# APPLICATION

PERCOLATION TESTING

SUBDIVISION CLEARVIEW ESTATES II LOT NO. 47A 50

ROAD AND DESCRIPTION 1200 MISTY RISE COURT

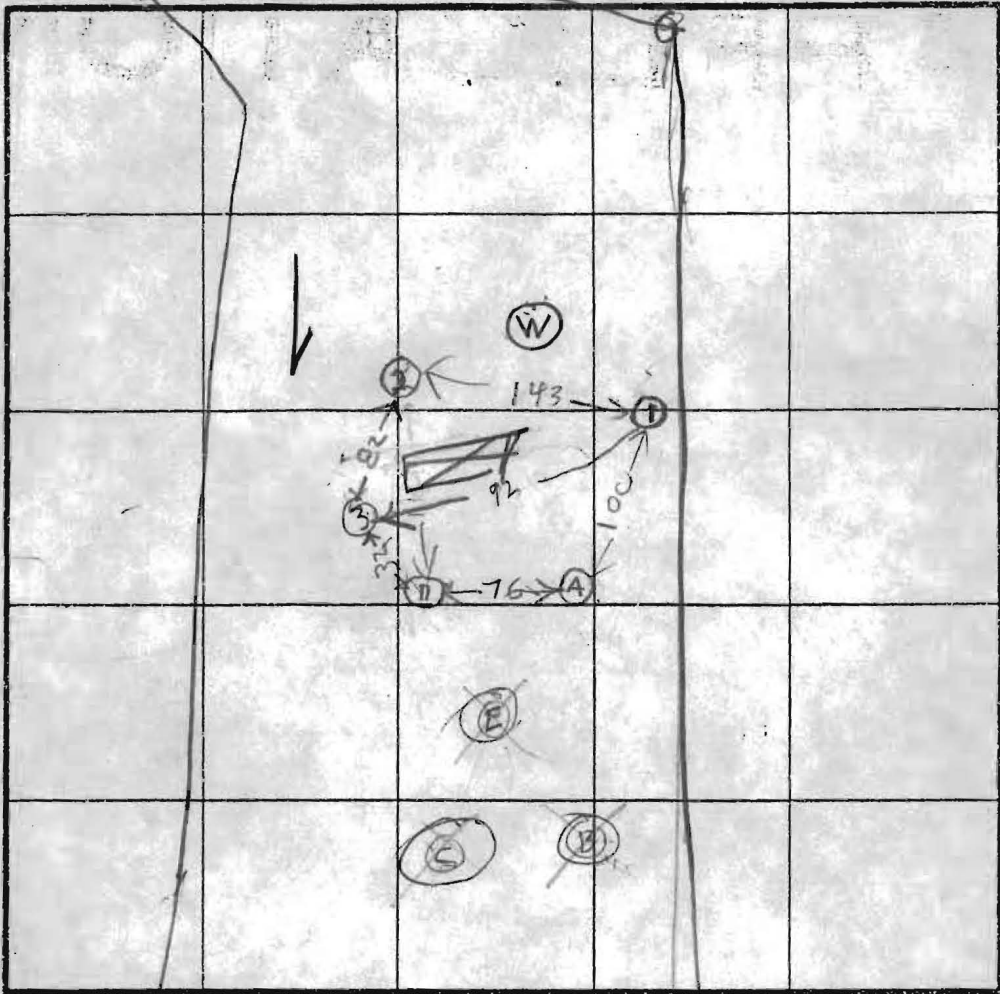
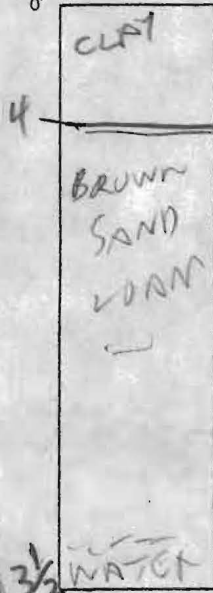
REASONS FOR REJECTION OR HOLDING 5/12/89 - PERC OK BUT HOUSE SITE & WELL SITES

MUST BE CHANGED HOLD FOR PERM KIT

REMARKS: Holes (A)(B)(C)(D)(E) DUG PER TEST PLAN HOLES (1)(2)(3) EXTRA HOUSE SITES & WELL SITES MUST BE CHANGED
